Sigtronics Panel Mount Intercom Sidetone Modification

Intercom Models: **Sport 200** Circuit Board 1528 S/N 6202993 - to - Current
SPA-400* Circuit Board 1528 S/N 6069006 - to - Current
SPA-600* Circuit Board 1528 S/N 1102528 - to - Current
SDB-800 Circuit Board 1528 S/N 1151486 A & B - to - Current

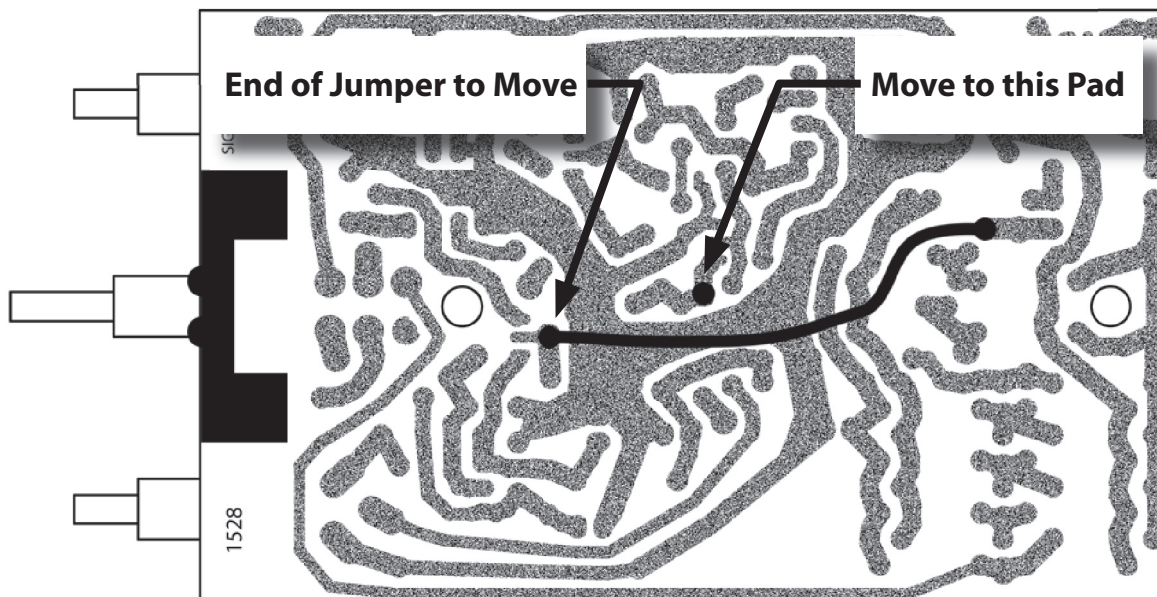
To complete the circuit board modification, remove the three screws securing the bottom cover to the case and carefully lift the cover from the case. Locate the jumper wire (usually brown in color) on the solder side of the circuit board. Note that the circuit board does not need to be removed from its case to complete the "side-tone" modification. Unsolder the wire from the solder trace at the end closest to the controls. Move the free end of the wire to the solder pad indicated in the attached drawing and solder the wire to the trace at the location specified.
